AMENDMENT #2
October 16, 2025
Invitation for Bids (IFB) Number
PCCD-25-PCW12Rehab-01, 9/18/25
Issued by
Plum Creek Conservation District
Lockhart, Texas

PURPOSE OF AMENDMENT

Amendment No. 2 (10-16-2025)
IFB PCCD-25-PCW12Rehab-01 (Site 12 Rehabilitation)

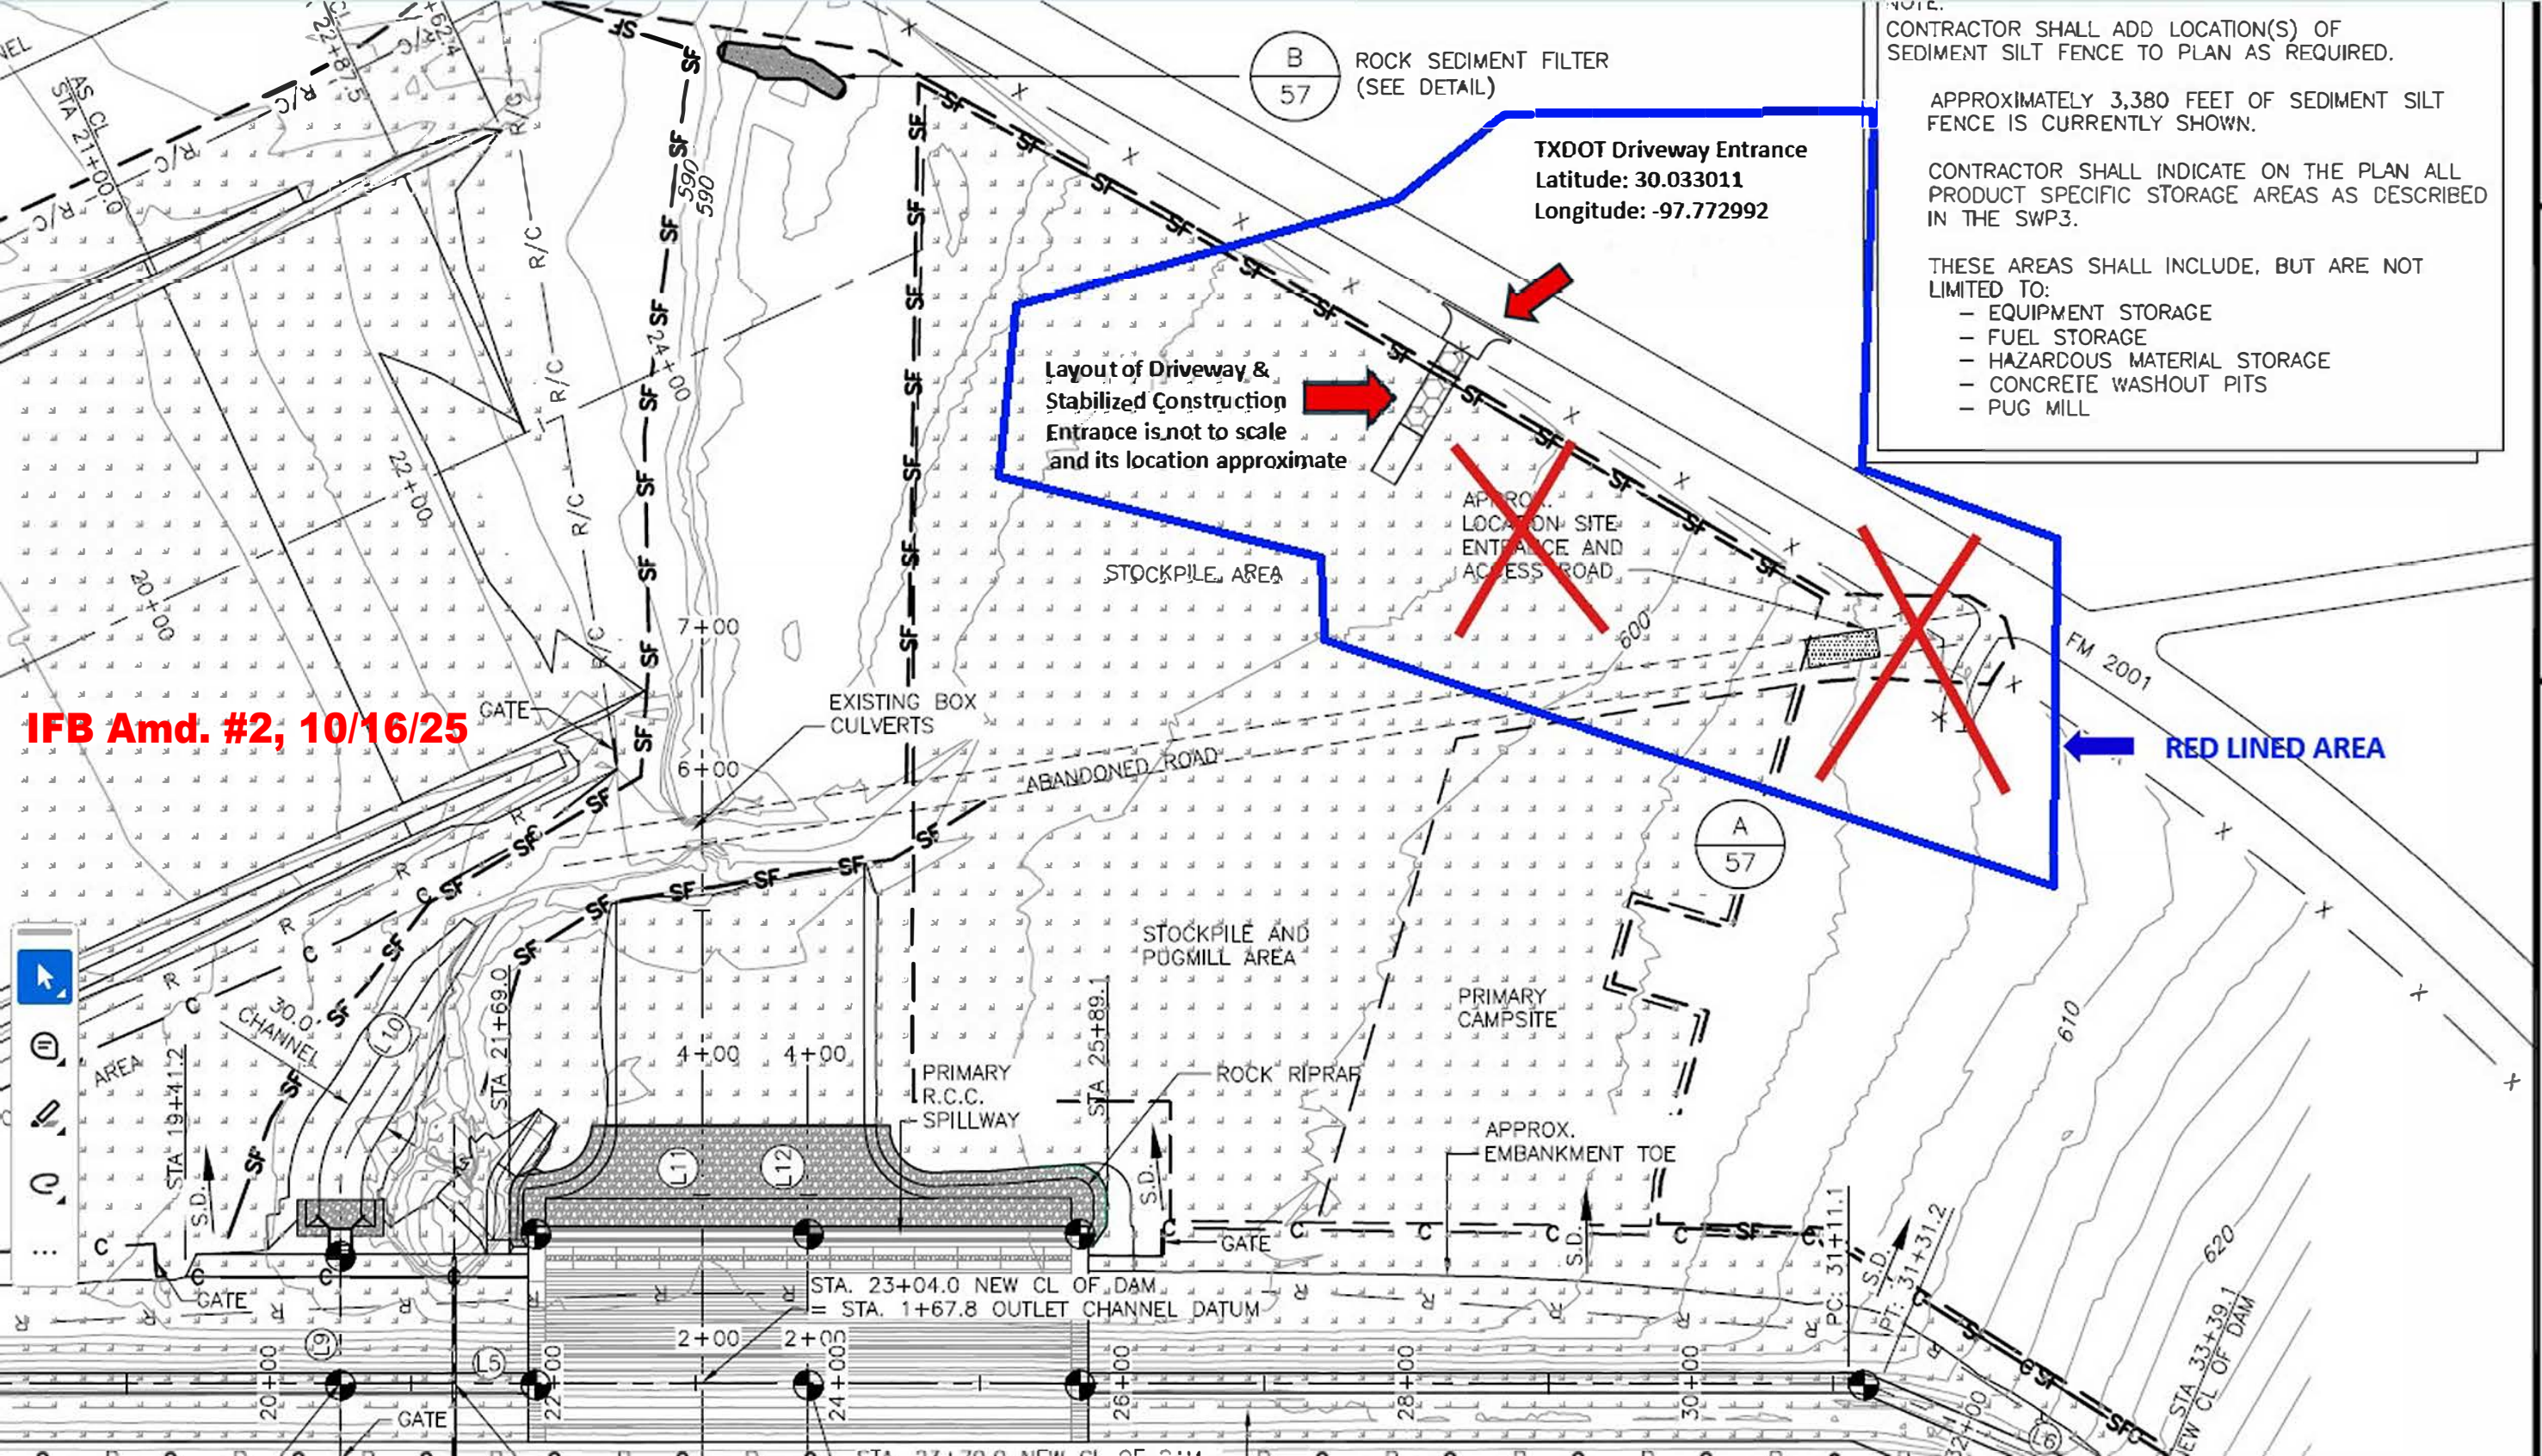
- Approximate TXDOT Driveway Location / Tentative Driveway Requirements – subject to any changes required by TXDOT for permit approval (2 pages):
 - Drawing Sheet 56 (reduced) shows approximate revised driveway/entrance location.
 - Driveway Detail as submitted to TXDOT by PCCD

TXDOT Driveway Entrance
Latitude: 30.033011
Longitude: -97.772992

**Layout of Driveway &
Stabilized Construction
Entrance is not to scale
and its location approximate**

APPROX.
LOCATION SITE
ENTRANCE AND
ACCESS ROAD

Driveway Detail

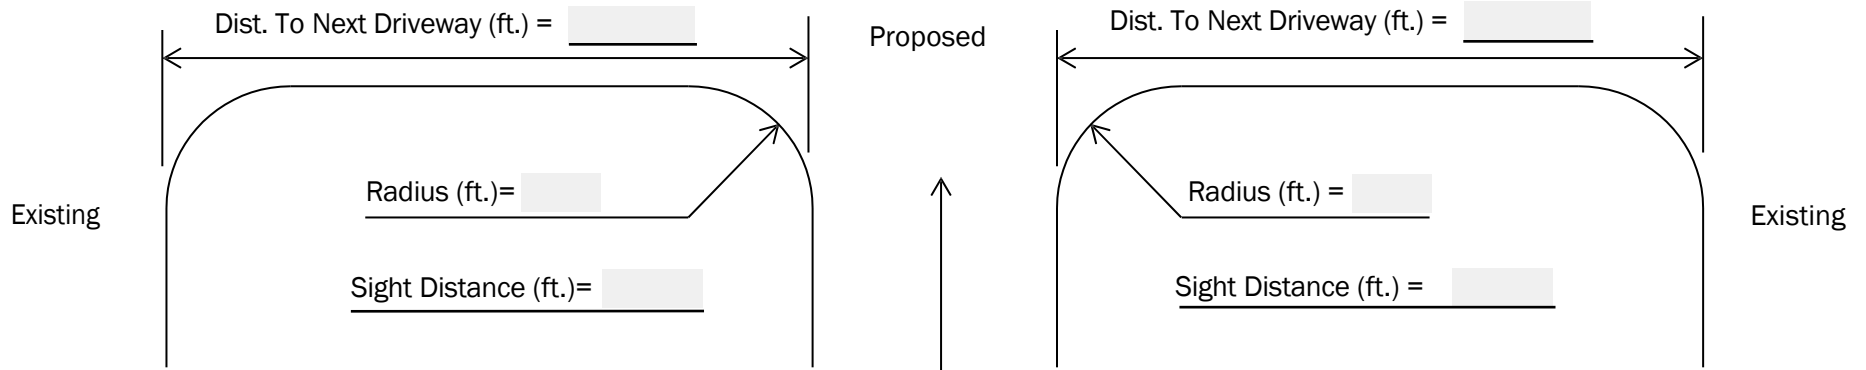
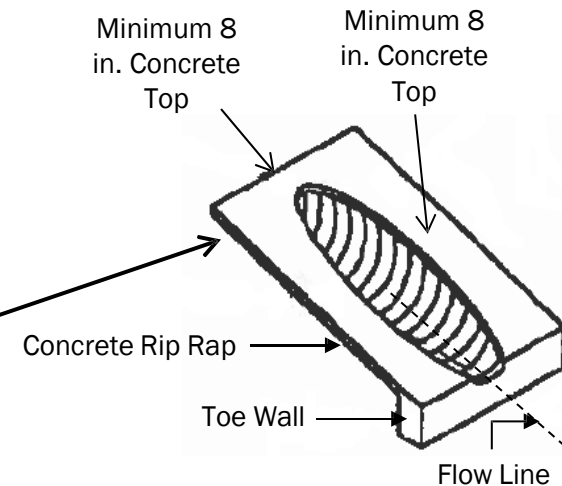
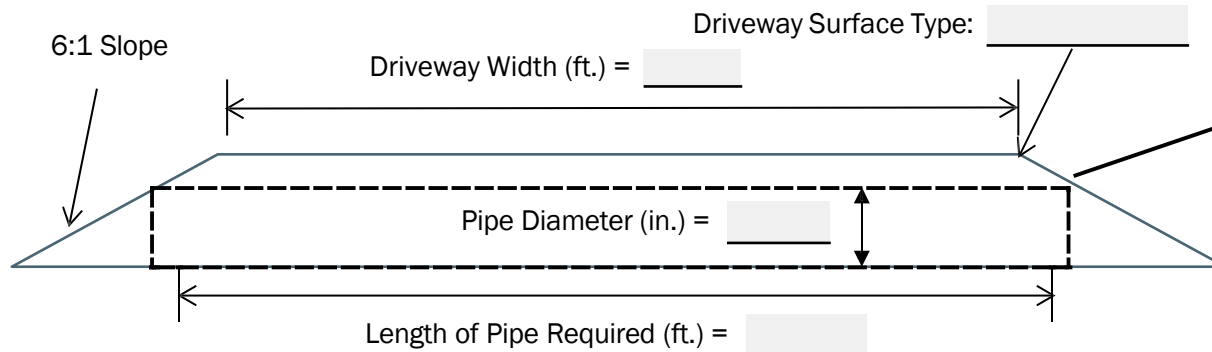
An IFB Amendment #1 Question/Answer stated the revised driveway location and TXDOT driveway detail requirements will be provided prior to bid date. However, to date PCCD's permit application has not been approved by TXDOT. However, the attached Driveway Detail was submitted to TXDOT with the permit request along with the attached Drawing Sheet 56 (reduced) that shows the approximate revised location of the entrance/driveway. **NOTE that this preliminary information is subject to change by TXDOT.**

Safety end treatment required on each end of the culvert pipe with concrete rip & rebar at a minimum 6:1 slope; 8:1 is preferred.
